#18258: Service Update - Wire Harness Potential Wear-Through - (Oct 21, 2018)

Models: 2017–2018 Chevrolet Camaro

Reference Number: N182167990	Release Date: October 2018
Revision: 00

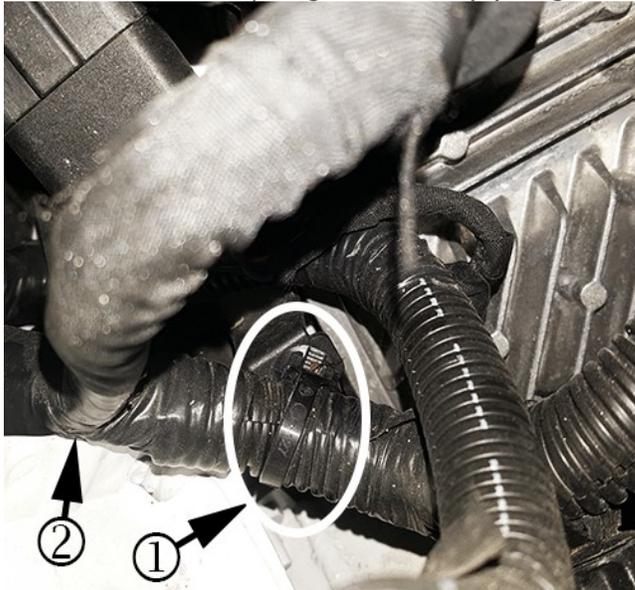
Condition	These vehicles were built without anti-abrasion wrap on the engine wire harness designed to prevent potential wear-through of the wire harness insulation over extended periods of time. If insulation wear-through were to occur, damage to the harness wires may result. Damage to individual circuits may result in diagnostic trouble codes (DTC's) being set. A service engine indicator may be displayed, and the engine may not start, run rough or run in reduced propulsion mode.
Correction	Dealers will add an anti-abrasion wrap and sleeve to area of contact.

2. Remove the battery negative stud (1) to gain access to the harness junction (2).

- Remove the harness clip from the (1) from the bracket to allow access to the harness junction (2).

- Apply anti-abrasion tape to the junction as shown, being sure to cover the harness completely, especially at the center of the junction where there is no convoluted conduit. The anti-abrasion tape should extend approximately 1 inch (25.7mm) out to each branch of the harness.

- Apply the high abrasion sleeve to the harness as shown fastening the Velcro around the upward branch of the harness. Then secure the sleeve with two zip ties, one on either side of the upward branch of the harness.
- Reinstall the harness clip to the fuse block bracket.
- Reinstall the battery negative stud. Tighten to 9 N-m (80 lb in).
- Reconnect the battery negative cable. Refer to *Battery Negative Cable Disconnection and Connection* in SI.
